Central Queensland Coal Project

CQC EPBC Proposed Decision Response

August 2022

Figure 3-1: Turbidity plumes: 8 April (left) and 28 April (right) 2017, showing natural colour (first) and the red-edge band (second, B5, black and white)

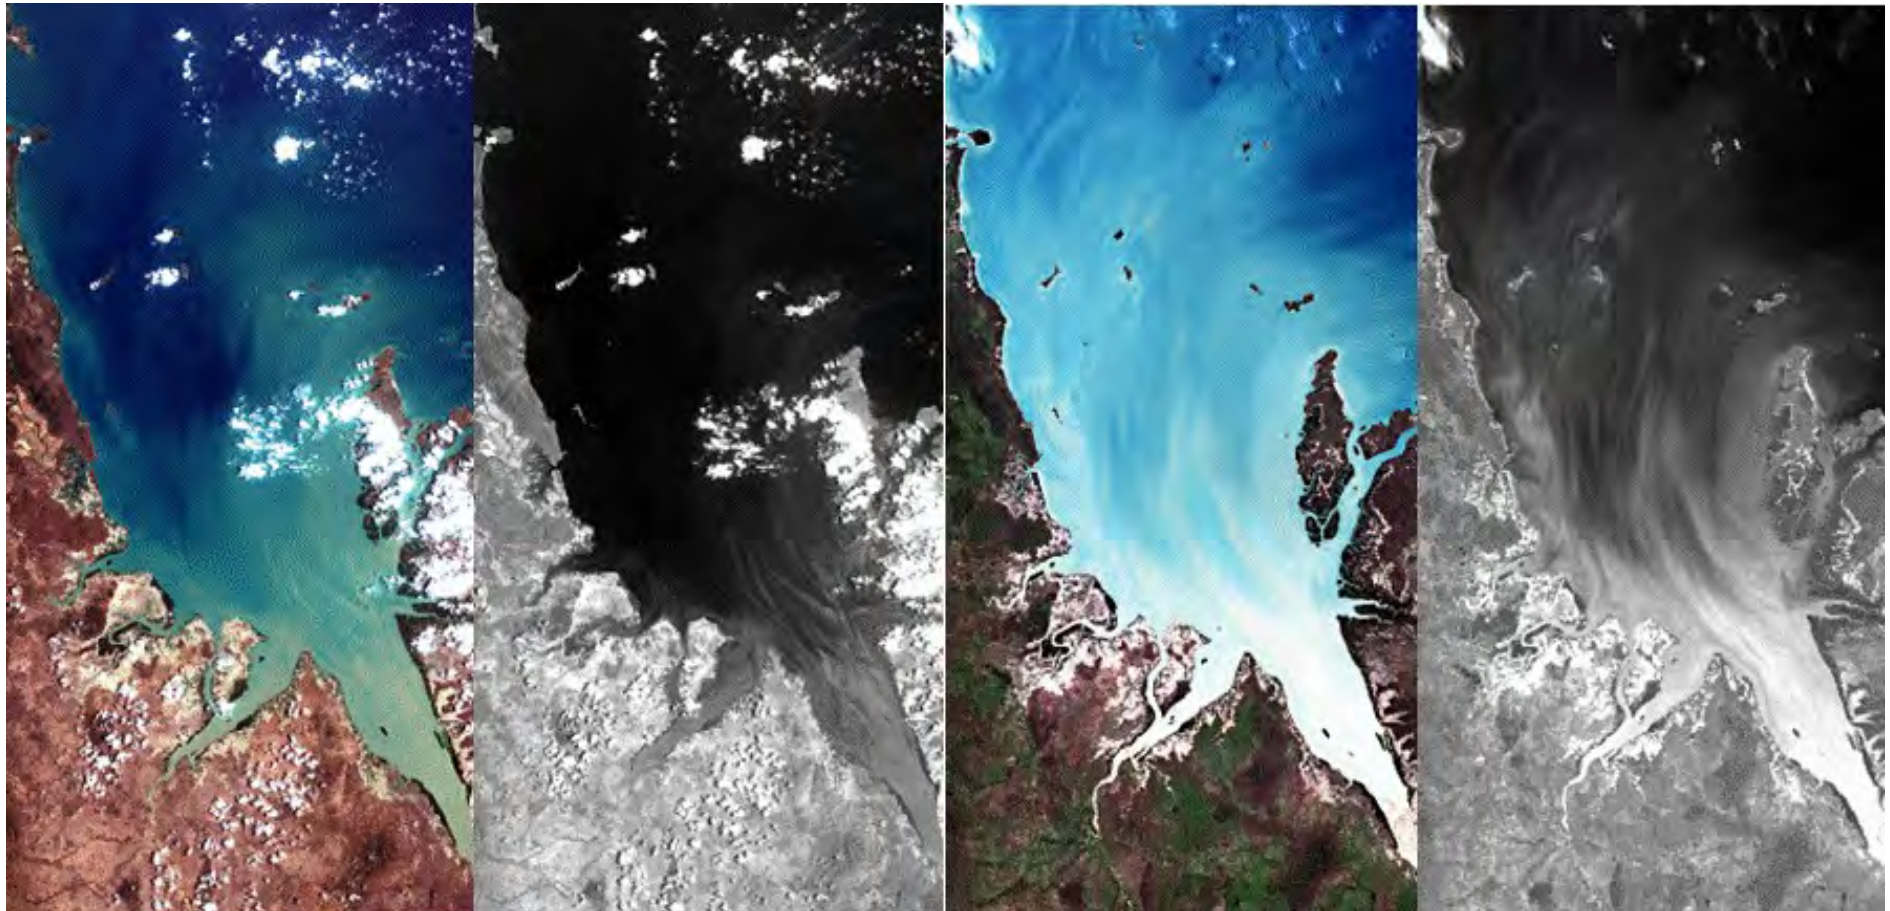
If the authors are to be believed, these major and irreversible changes must already be occurring. Since the project will reduce sediment loss from the site, the natural turbidity plumes shown below would be less rather than more intense.

Figure 3-2: Turbidity plumes: 24 December 2019 (left) and 12 April 2021 (right), showing natural colour (first) and the red-edge band (second, B5, black and white)

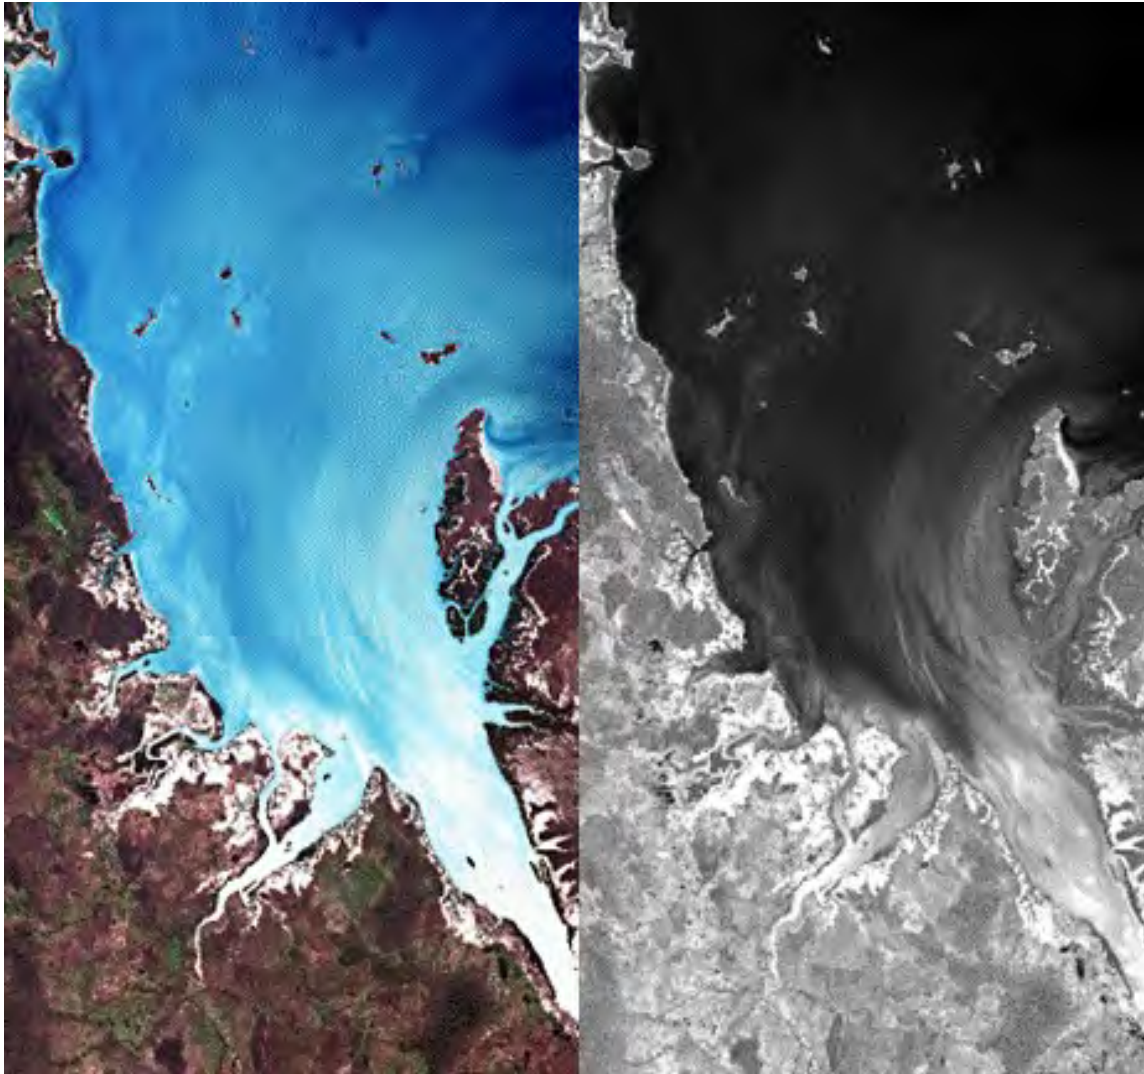
Based on their dubious report, if the authors are to be believed, these major and irreversible changes must already be occurring. Since the project will reduce sediment loss from the site, the natural turbidity plumes shown in Figure 2-1, would be less rather than more intense.

Figure 4-3: Norwich Park Mine and Dysart Township

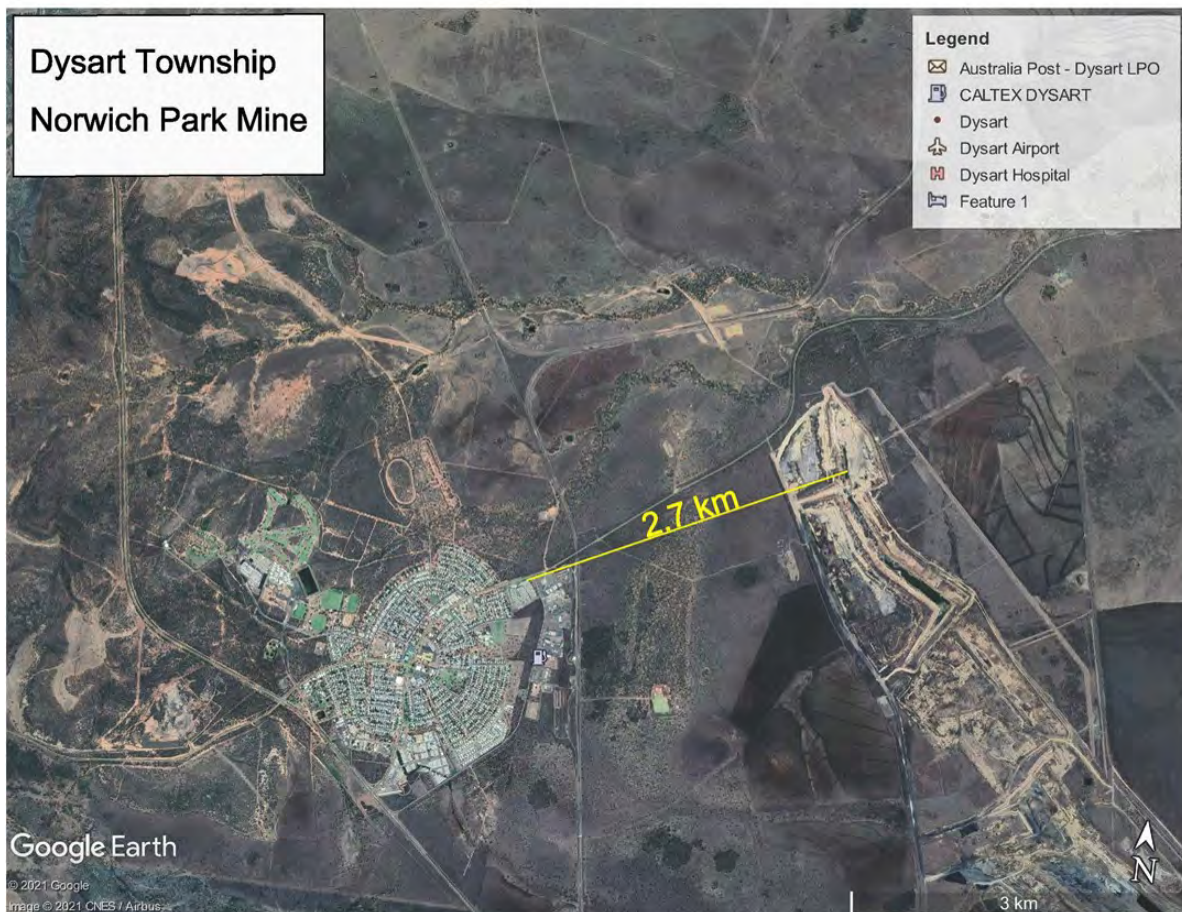
Major coal mines such as Caval Ridge (11.0Mtpa) and Isaac Plains (2.4Mtpa) are located within 6.0km of the Moranbah Township with a population of over 8,500. Middlemount Coal Mine produces 3.6Mtpa of coal and is located 5.0km from Middlemount Township. Norwich Park Coal Mine produces 5.5Mtpa and located 2.7km from the township of Dysart, population 3000. All these mines operate successful overburden blasting operations, in particular blast fume management as per the regulations of Department of Resources Safety and Health Queensland. See Figure - Norwich Park Mine and Dysart Township.

Figure 4-6: Mt Coot-tha Quarry – 5.0km from Brisbane City CBD

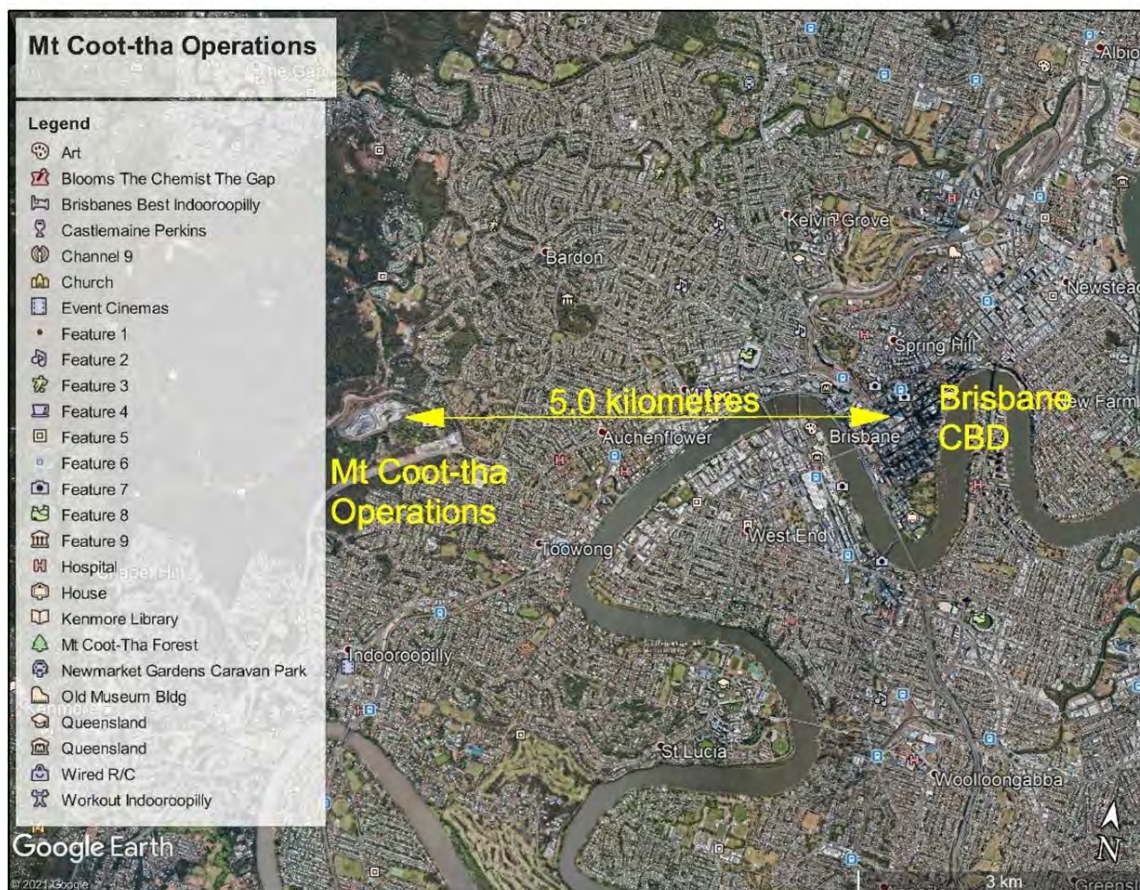
Blast fumes can be reduced by improved stemming of blast-holes, blast detonation delays, use of low fume explosive and management processes, including avoidance of blasting during inclement weather. These matters are essentially run-of-mine controls, which will be addressed in that context, but would not necessarily be expected to be included in an EIS in such detail. AEIS, Chapter 13, Section 13.8.2 - Mitigation for Blasting, details the mitigation measures that will be put in place, in particular, development of procedures in conjunction with DTMR at least 3 months prior to any blasting that may affect the Bruce Highway. There are numerous examples where blasting close to major roads has occurred safely throughout Queensland under government regulations such as Peak Downs Mine, Norwich Park Mine and Mt Coot-tha Quarry, to name only a few.

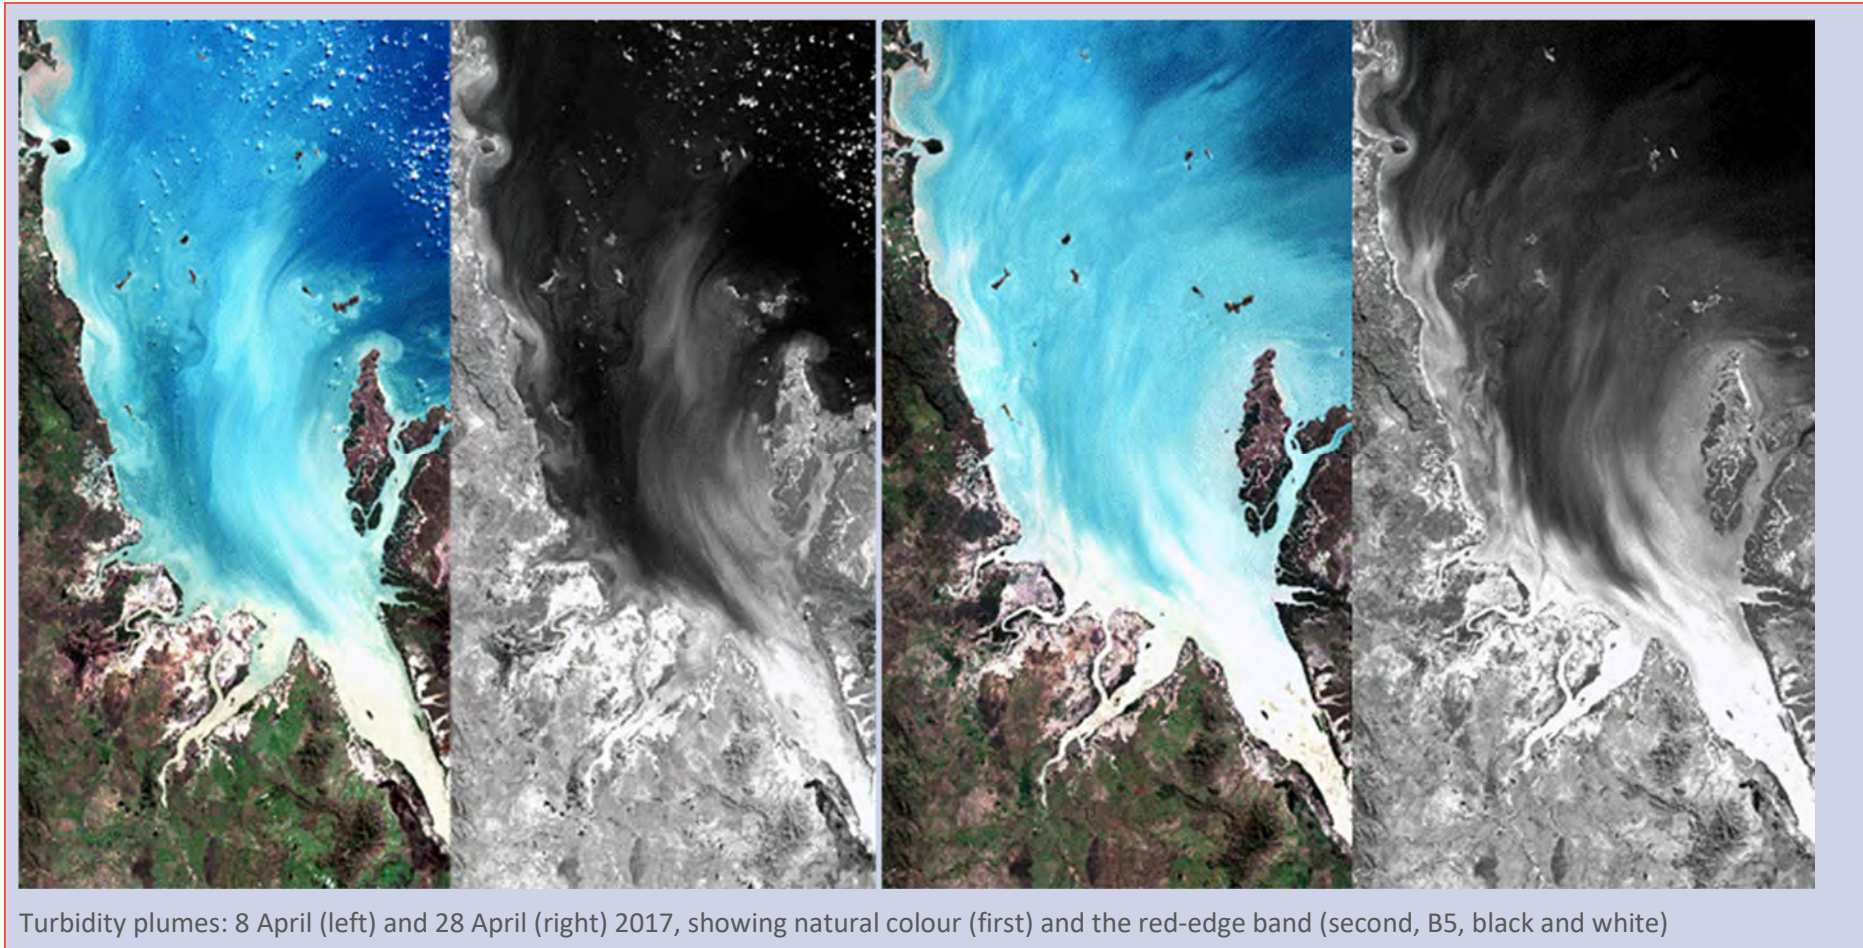
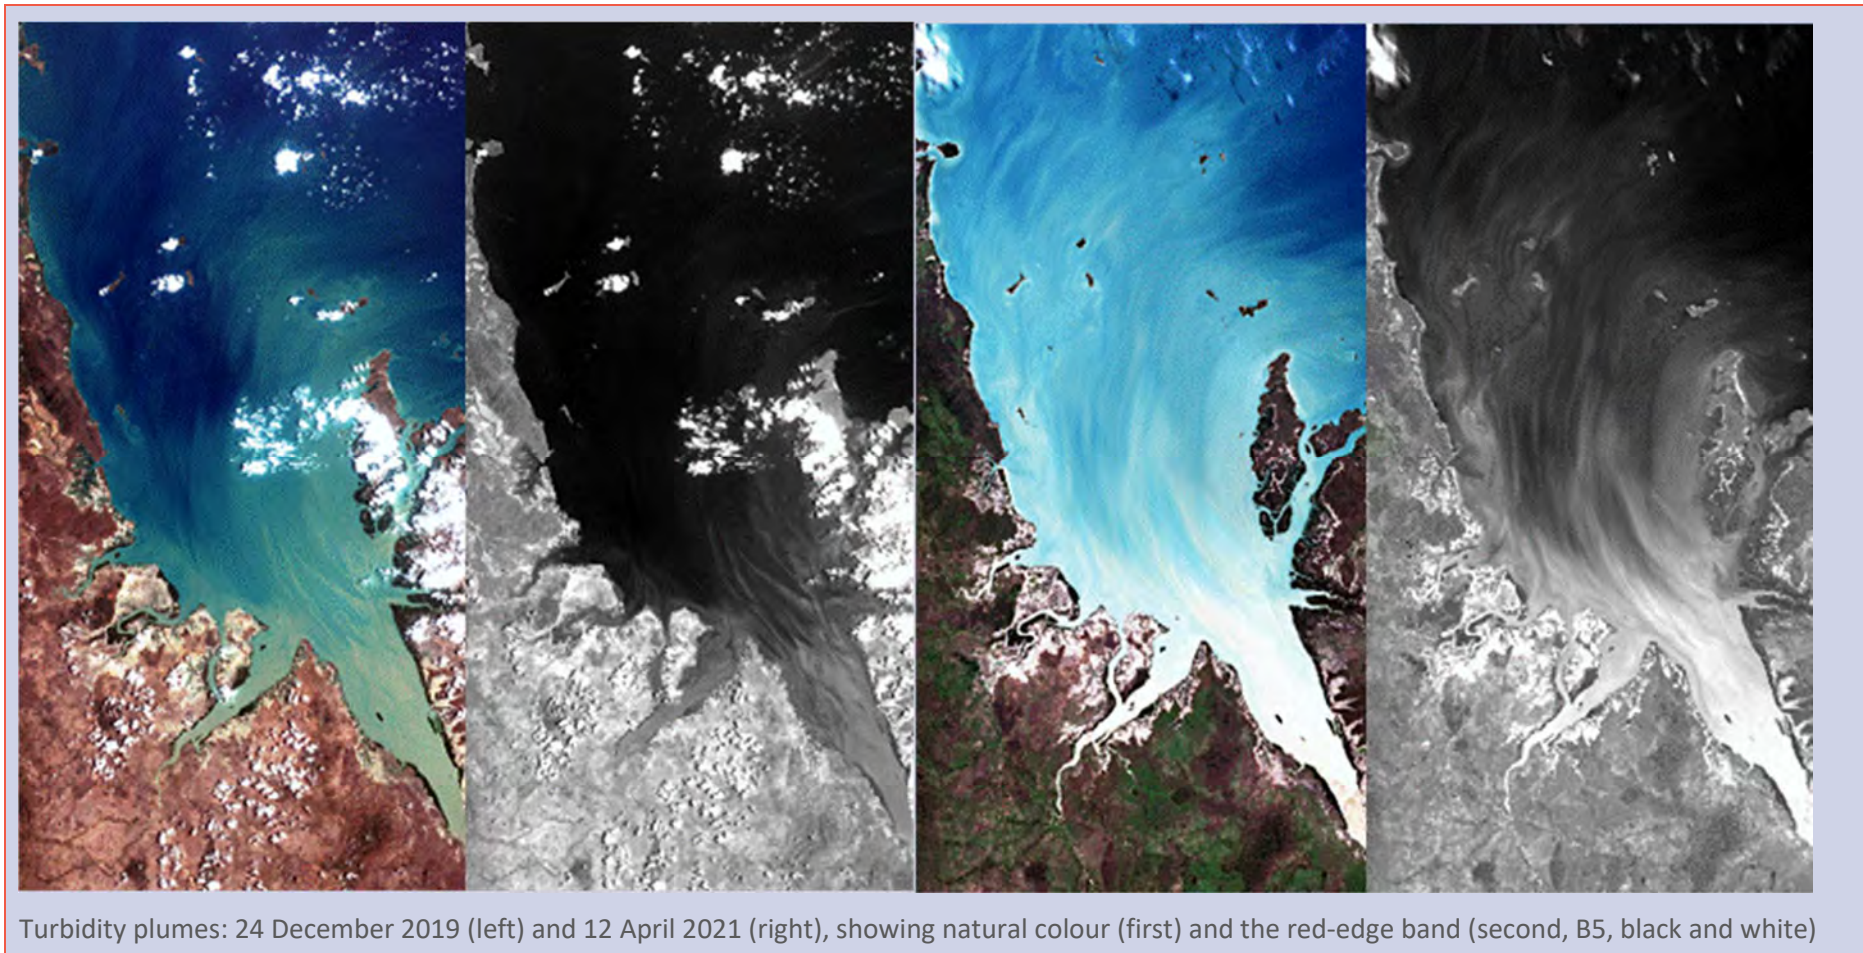
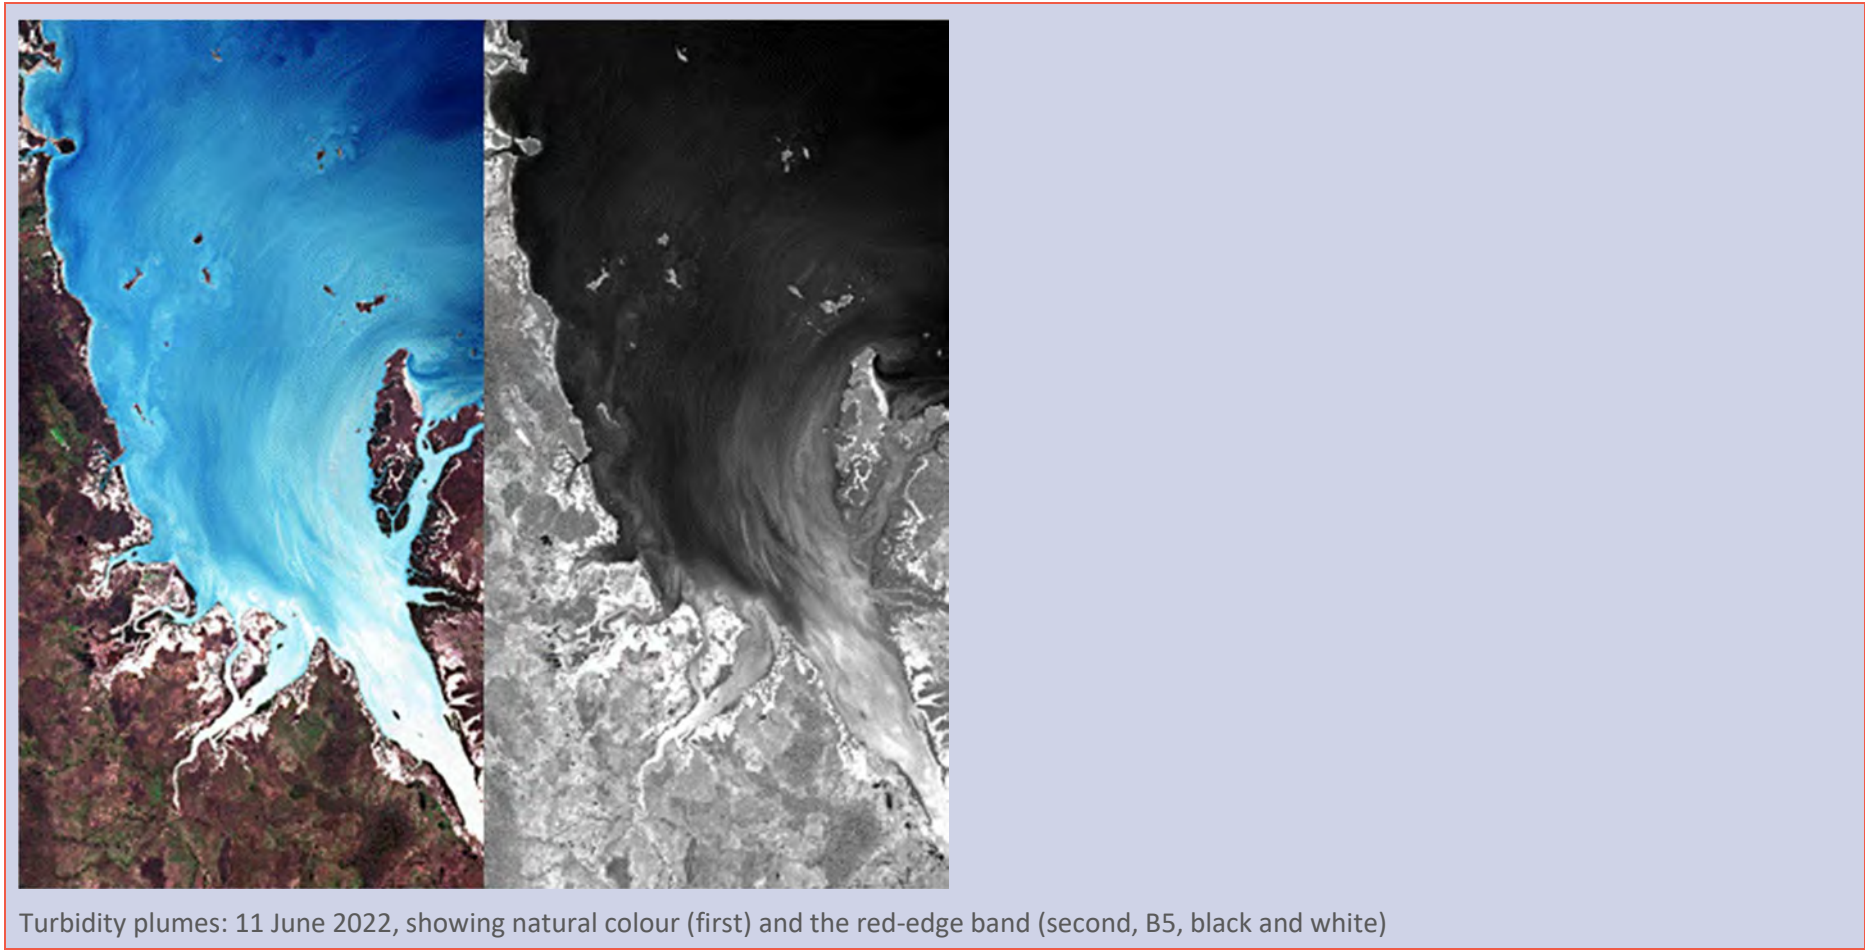
40. The research article states some assumptions were made about the discharge rates of the Styx River. In the absence of discharge measurements, it was considered that the water flow during high river discharge seasons would be sufficient to flush sediments out into the Broad Sound.

41. The department considers that, while some assumptions were made regarding the sediment modelling, there is sufficient evidence to suggest that sediments finer than 32 μm associated with mine affected water from the Central Queensland Coal mine would reach Broad Sound and cause significant damage to important sea grass habitats via processes such as smothering, burying and reduced light penetration.

Noted. See response below at paragraphs 41.

CQC has reviewed the paper discussed in the above paragraphs 37 – 41. While the department acknowledges that assumptions were made, it appears they have failed to note several very important elements of the study – in essence, while an interesting examination of potential flow patterns, the substantial issues with the paper that appear to have not been considered are:

- The model has not been validated for tide or flow patterns in the inshore area the model is focused on (the validation is made over 200km away and well outside the Broad Sound bay and nearshore areas)

- The model did not validate sediment plume dynamics, most importantly ignoring the very high existing sediment loads in the region, which contain a high proportion of clays in existing runoff.
